# Four H Lingerie Ltd.

BRTC Bus Depot, Baluchara, Hathazari Road, Chittagong, Bangladesh  
(+22.416298N, 91.819663E)

2<sup>nd</sup> July 2014

# Observations

Column-rafter connection at valley

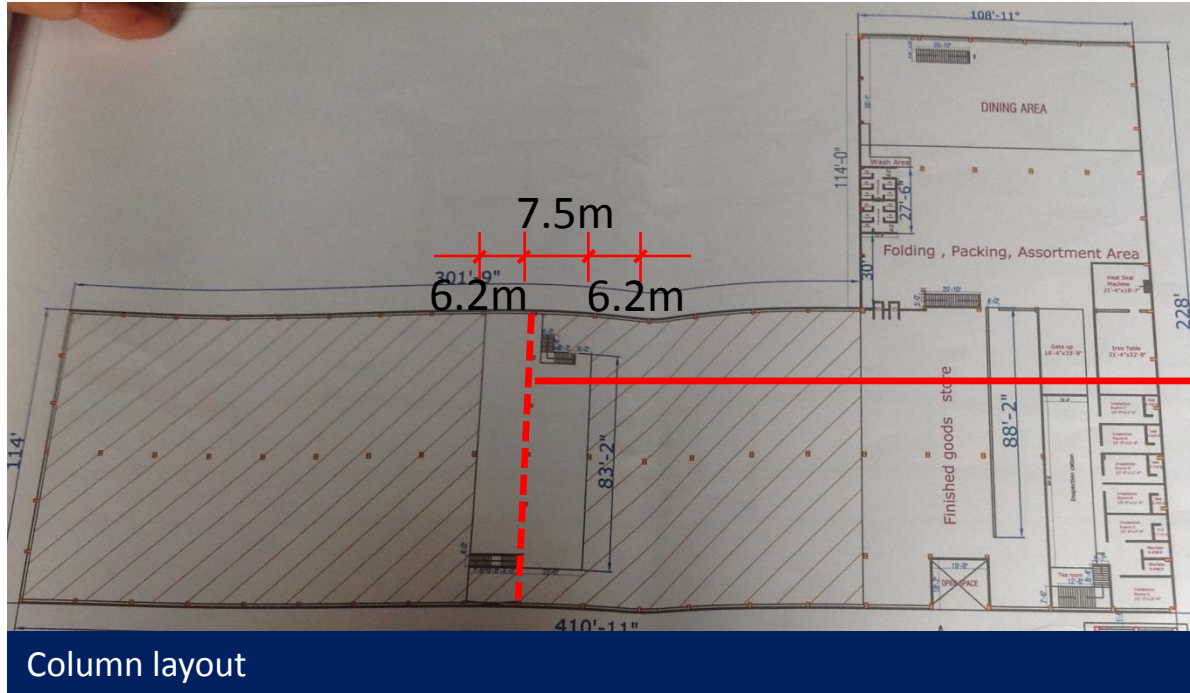
# Moment transfer between portal frames compromised due to connection recess for gutter.

- Column with haunch
- Rafter sitting on top of haunch
- Gutter drain

6	Apparently Inadequate Steel Connection Design	Where required, remedial measures to steelwork to be carried out.	6-months
